**PATTON MARINE SURVEYORS
And CONSULTANTS, INC.**
P.O. Box 331884
Miami, FL 33233-1884, USA

December 14, 2024
File No.: 13717-24
Page 1 of 22

**RE: "SAPPHIRE", 2009,
50.44 Meter Trinity Motor Yacht**

RECOMMENDATIONS

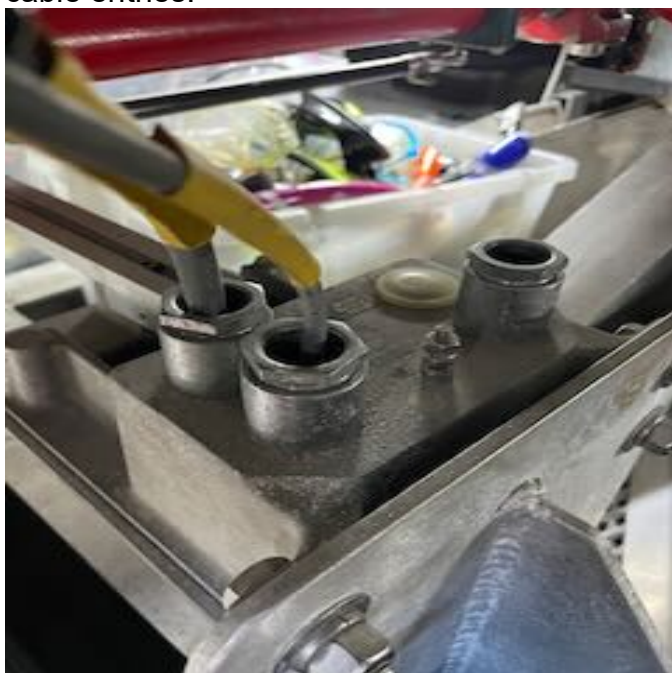
4. The air conditioning systems supply cable is not conforming to bend radius minimums, the cable is generating heat captured at 35.5°C. Relieve this cables tight bend and re check running temperature.

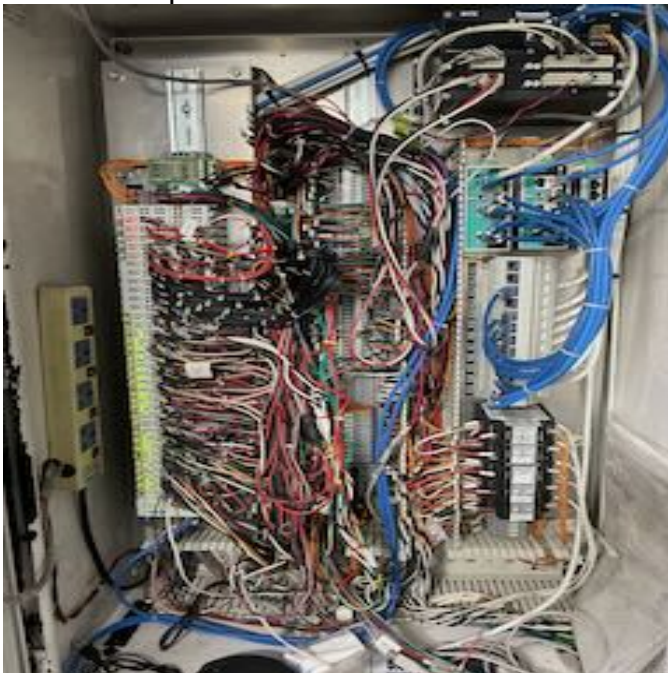
5. Supply cable to the fire pump has pulled from the motor connection housing. Re-install this motors supply cable. Multiple cable runs in the engine room, especially under the deck plates require additional cable support and protection.
